**RE-EVALUATION**  
of the  
**Environmental Assessment**  
**US 95 Northwest – Washington Avenue to Kyle Canyon**  
**Clark County, Nevada**

**FHWA-NV-EA 07.01**

December – 2012

**Project Name:** US 95 Northwest – Washington Avenue to Kyle Canyon Road

**Figure 1-5a Repositioned Sound Wall S234**

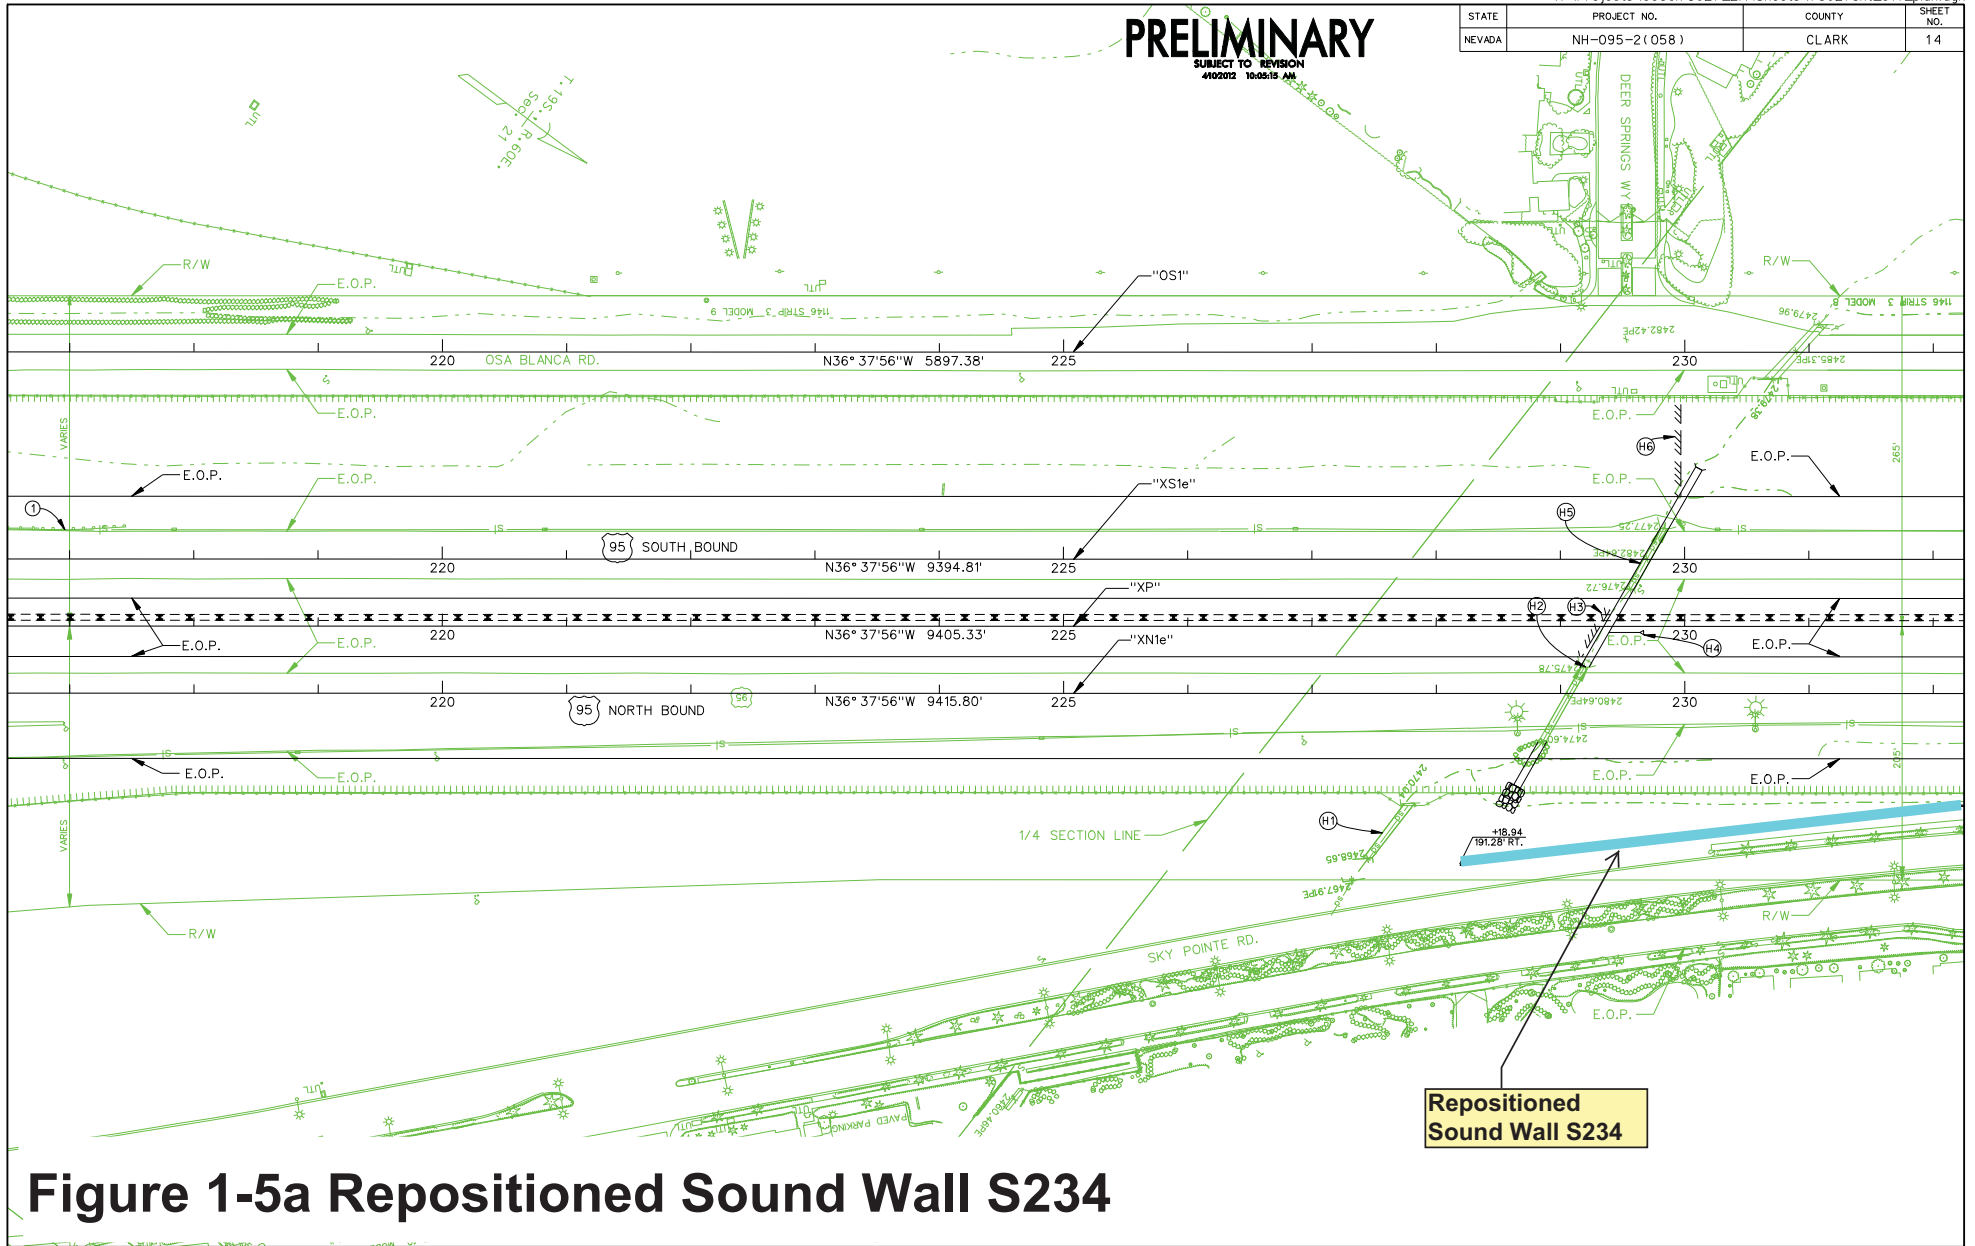
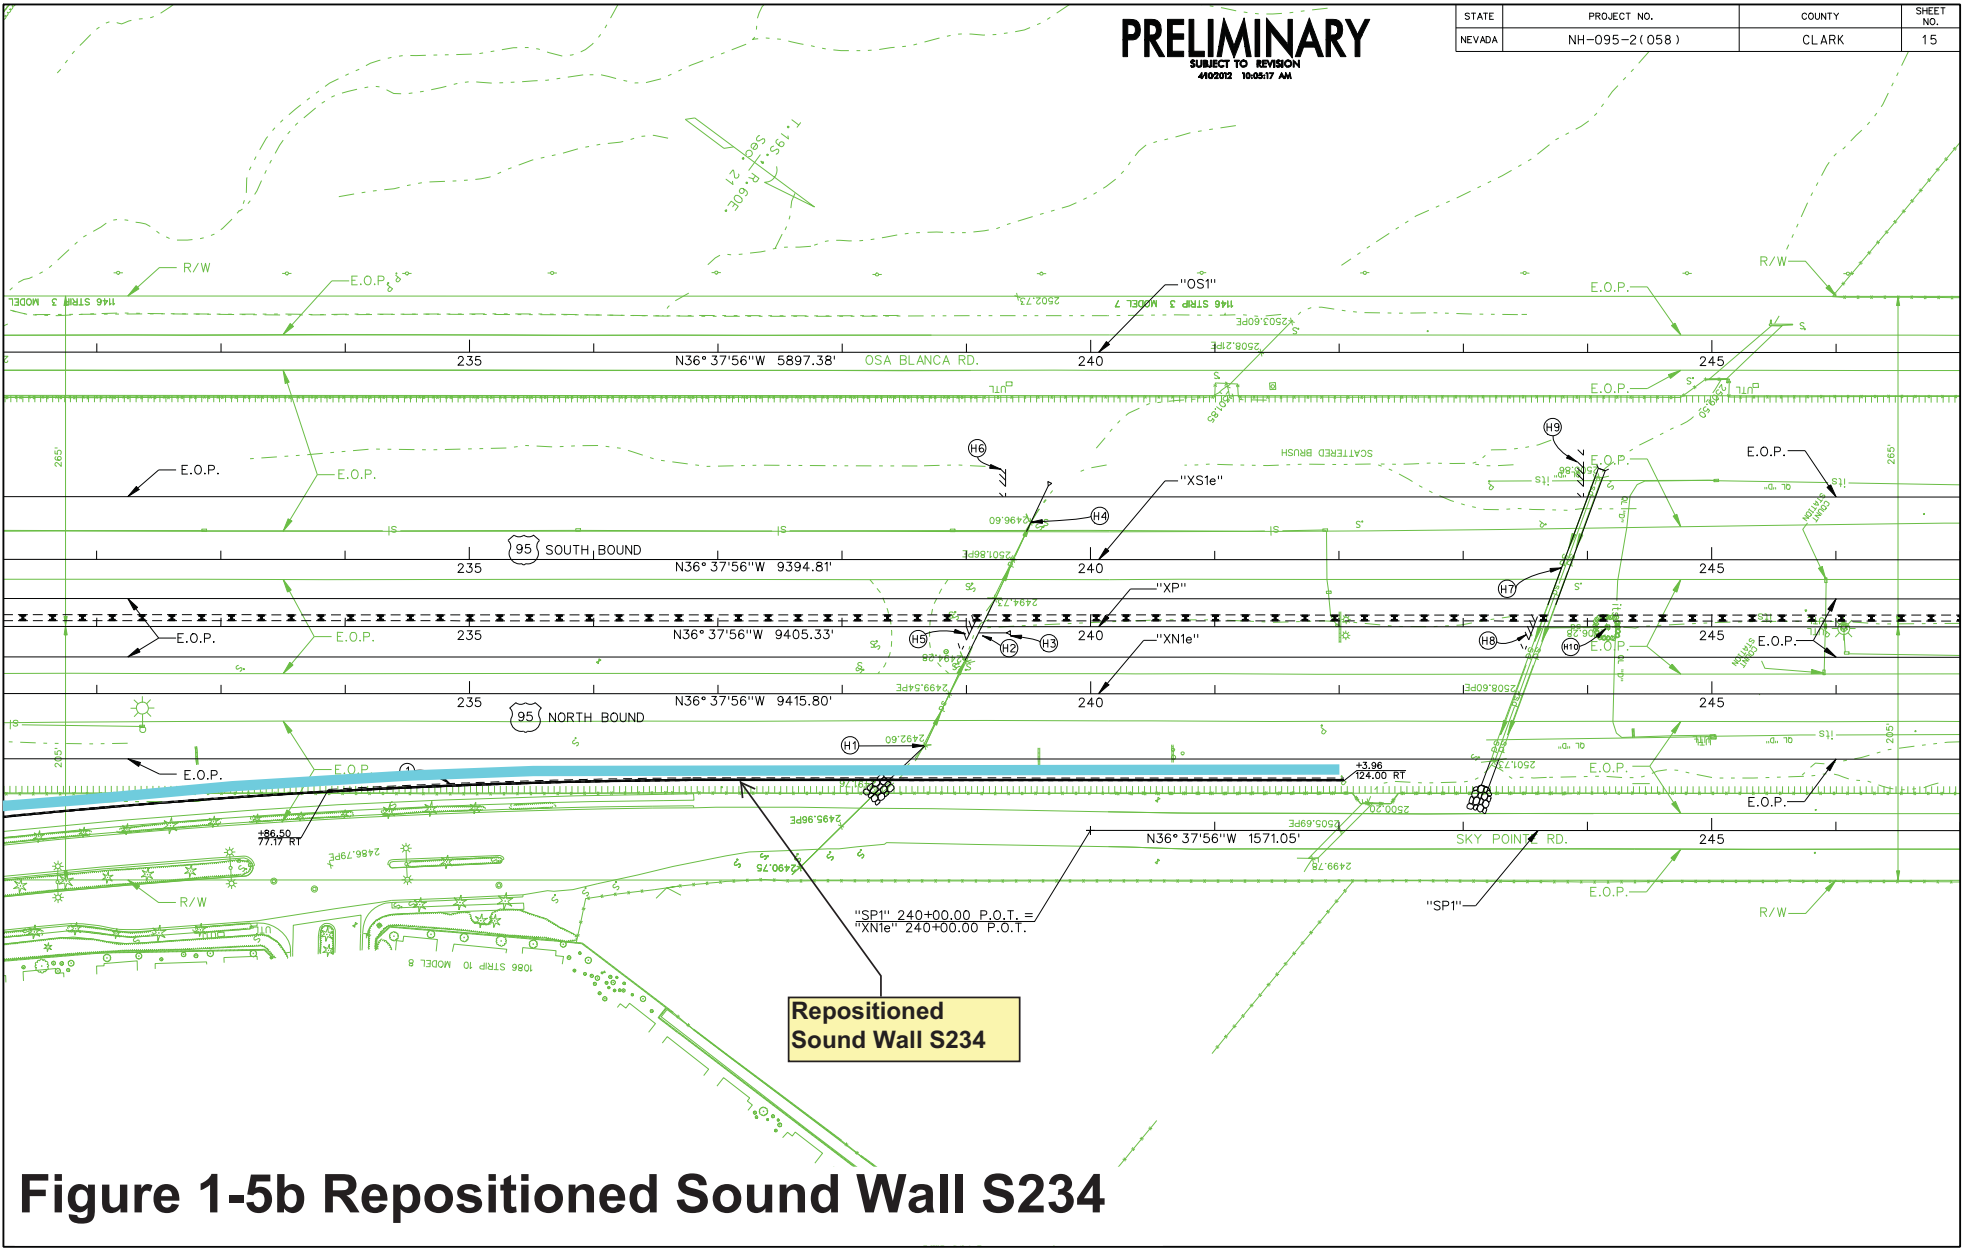
The sound wall (S234) is located east of US95 and north of the CC-215/US95 interchange (*Figures 1-5a and 1-5b*). A request was made by NDOT Hydraulics Division to reposition the southern portion of S234 due to hydraulic features requiring drainage improvements. The re-analysis indicated this request was possible and the southern extent could be terminated near the necessary drainage improvements. This was accomplished by not only maintaining acoustical feasibility, but by achieving the traffic noise reduction design goal with an insertion loss of 7 dB(A) at the identified receivers.

**Figure 1-6a Sound Wall S278**

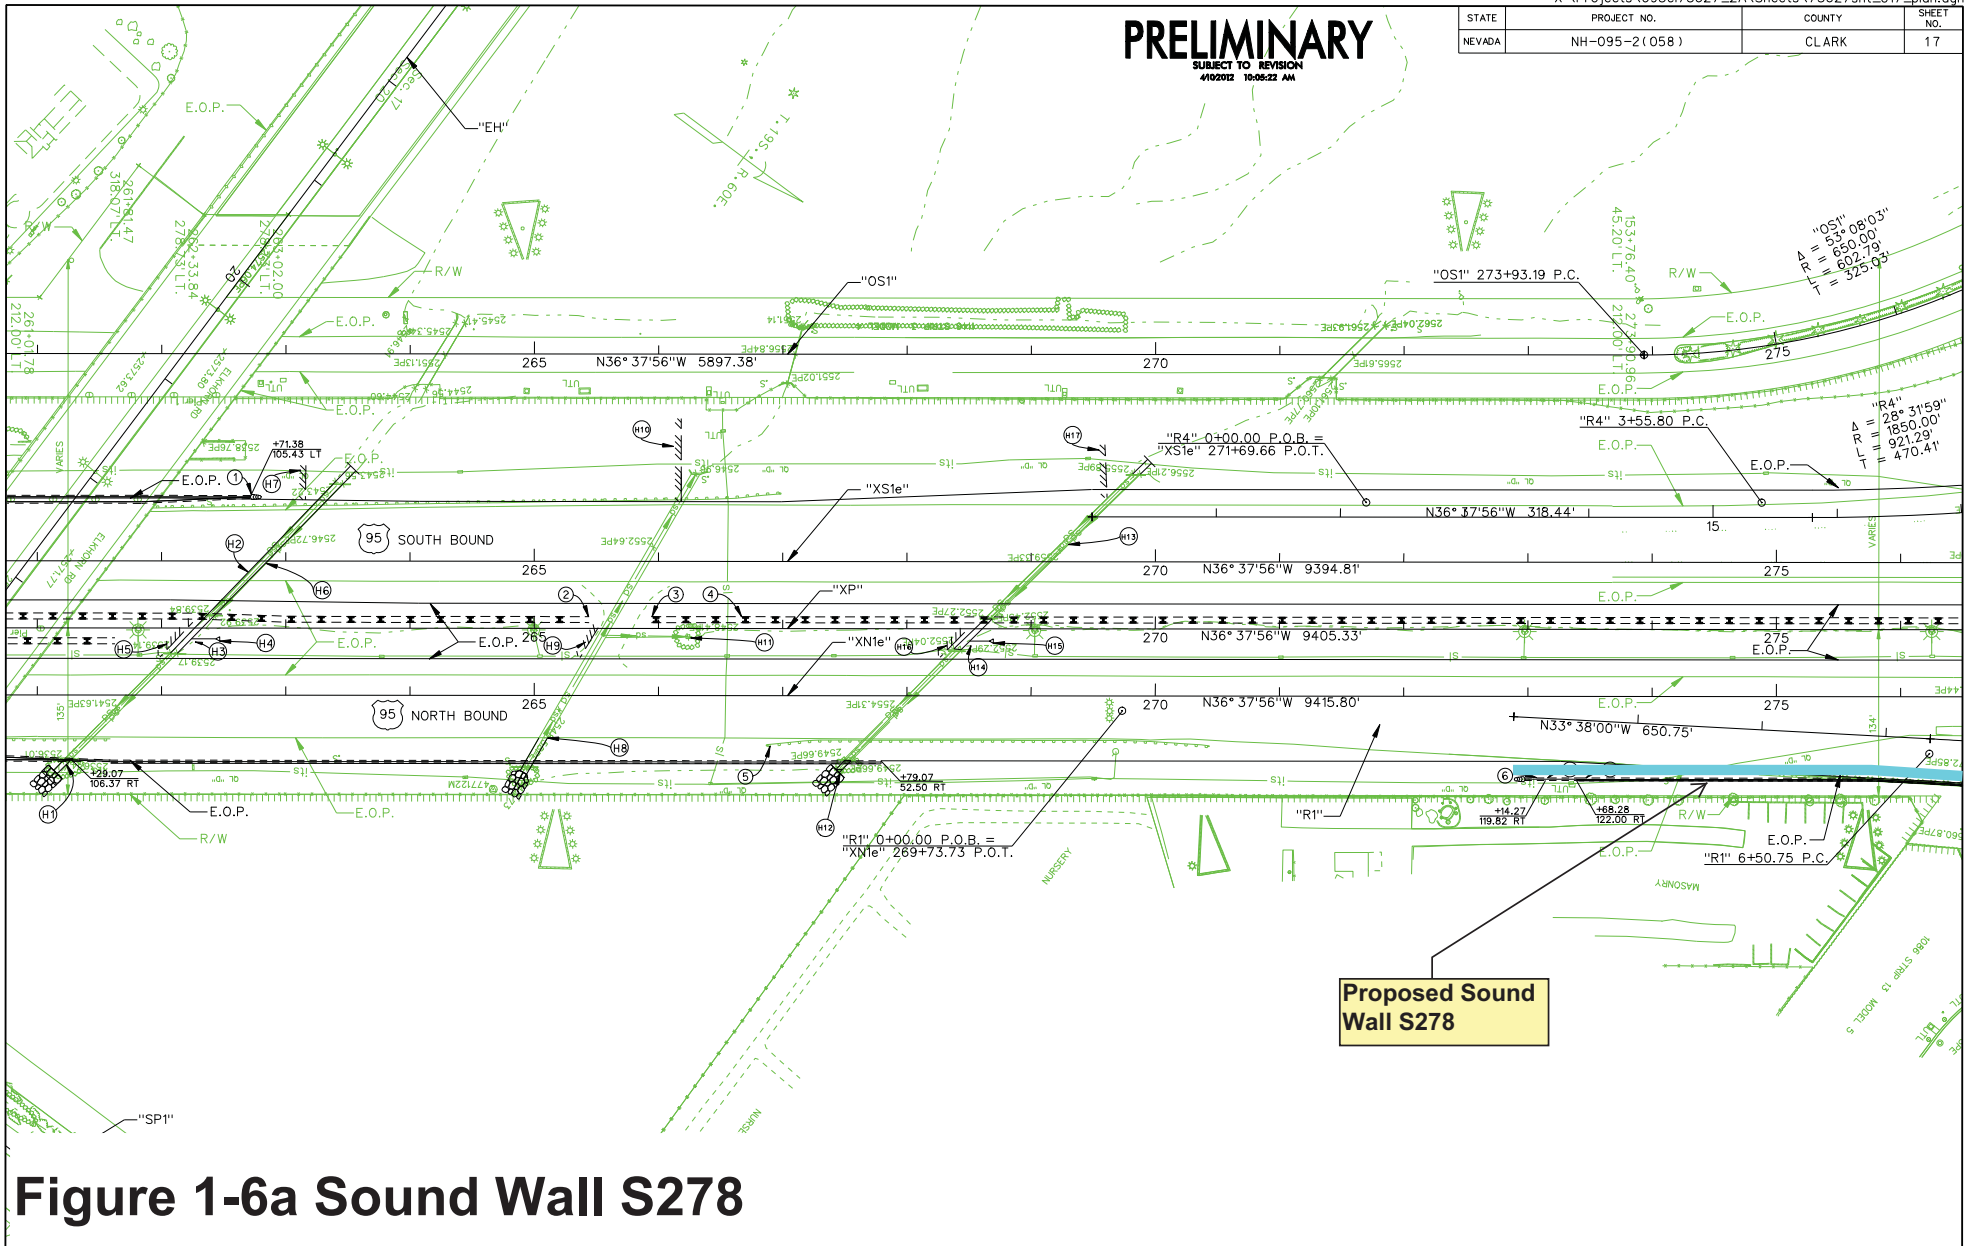
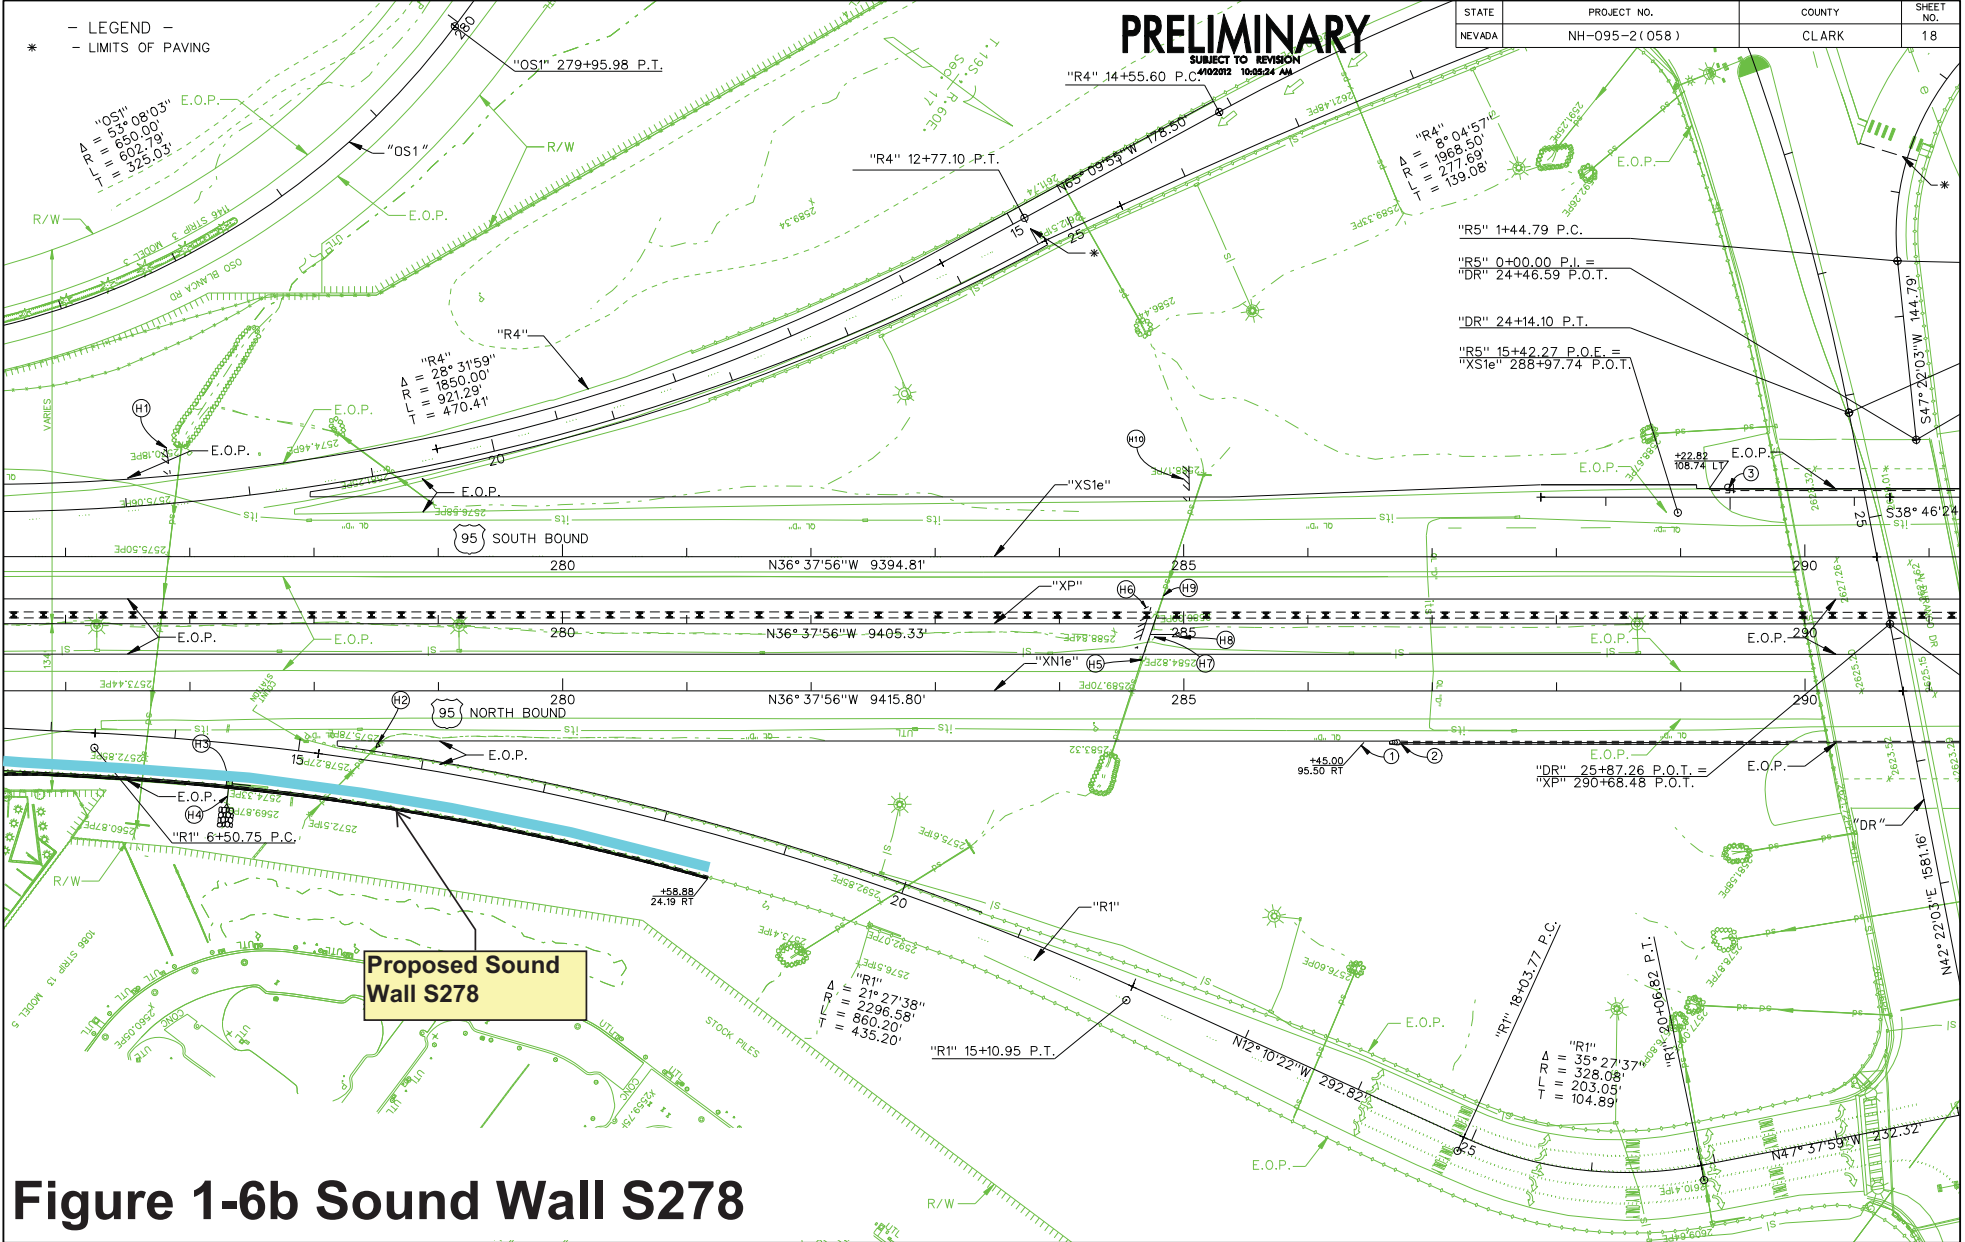
The sound wall (S278) is located east of US 95 and south of the Durango Drive interchange (*Figures 1-6a and 1-6b*). It was re-evaluated due to its proximity to commercial property and billboards (Activity Category F). Updated conditions were used in remodeling this sound wall and included definitive dimensions of a property/privacy wall shielding the identified residential development (Activity Category B). This allowed reducing the extents of this sound wall and prevents visually blocking commercial facilities. This was accomplished by not only maintaining acoustical feasibility, but by achieving up to the traffic noise reduction design goal with an insertion loss of 6-7 dB(A) at the identified receivers.
